# Economic and Social Council

###### European Code for Inland Waterways (CEVNI)

### Amendments to Annexes 1–8

#### Transmitted by the CEVNI Expert Group<sup>1</sup>

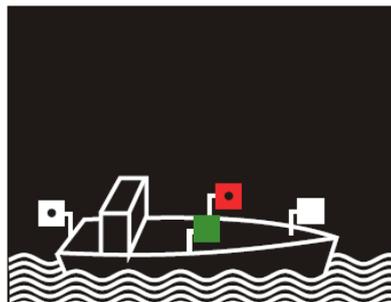
b) Amend paragraph 1.3 as follows

i) Amend the first sentence as follows<sup>3,4</sup>

Fixed light visible from all directions (a light projecting an uninterrupted beam throughout a horizontal arc of  $360^{\circ}$ ).

c) Sketch 48

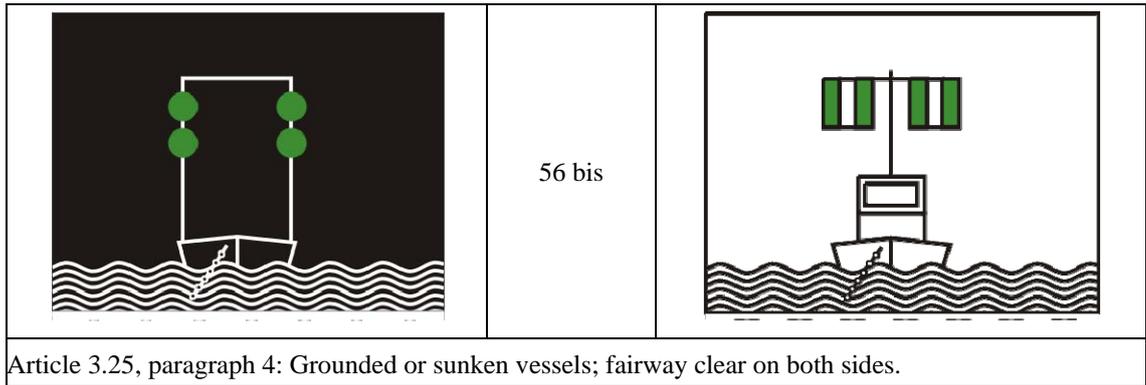
Delete the sketch showing the day marking<sup>5</sup>

30. Section V, A and B: *Correct the text of the titles A and B as follows<sup>3,4</sup>*

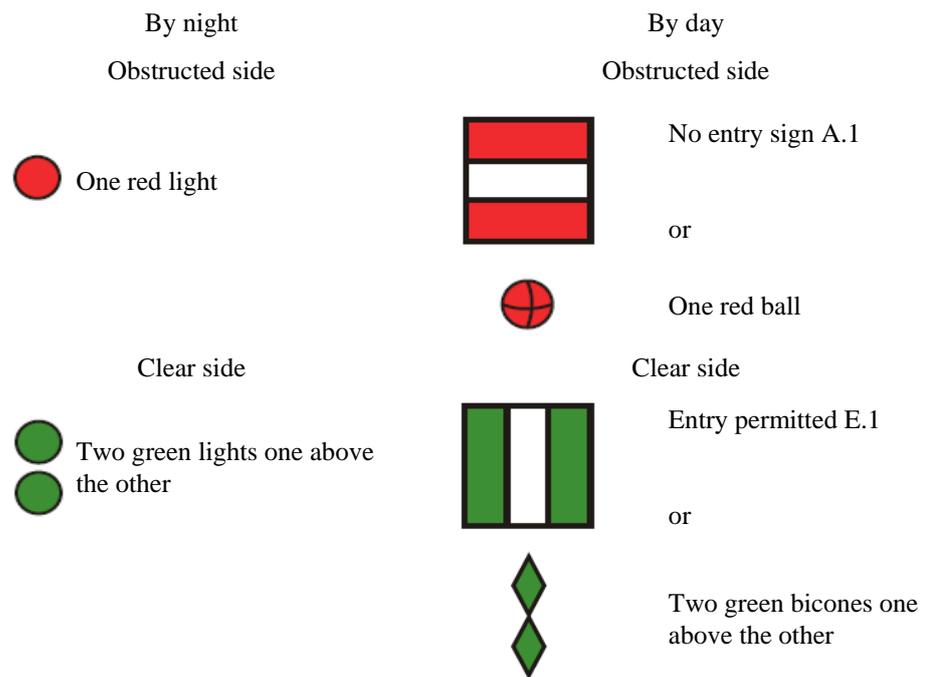
A. Marking of bridge piers (~~if necessary~~ **where applicable**)

B. Marking of overhead cables (~~if necessary~~ **where applicable**)

(fig. 17 bis)

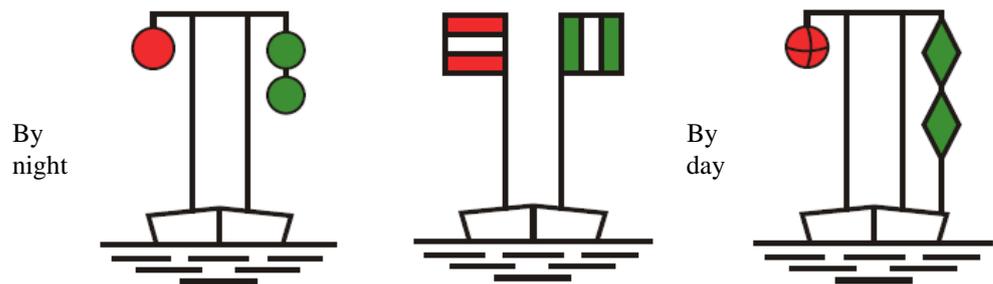
31. *Add a new section IV bis reading<sup>5</sup>*

**IV bis. Other marking of danger points and obstacles in the waterway**

1. Passage permitted on the clear side without reducing speed

(fig. 17 ter)

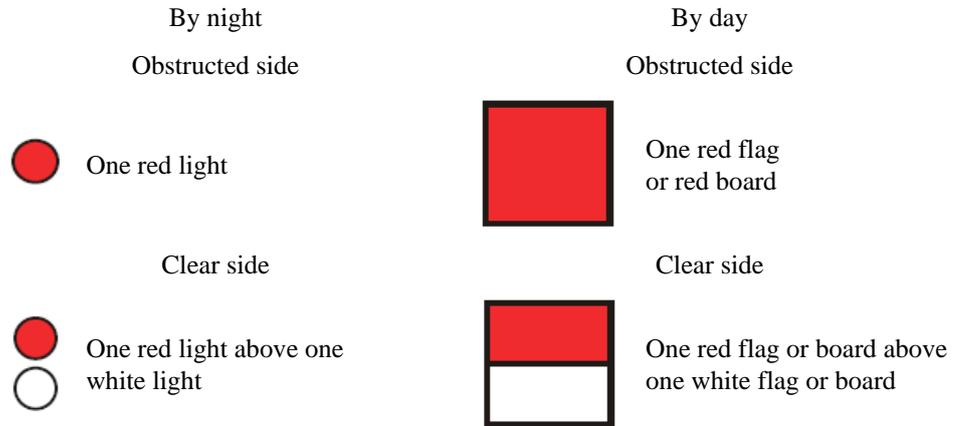
Example:

(fig. 17 quater)

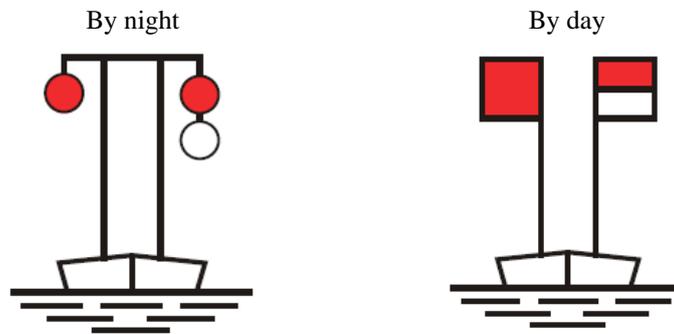
2. Passage permitted on the clear side at reduced speed (avoid creating wash)
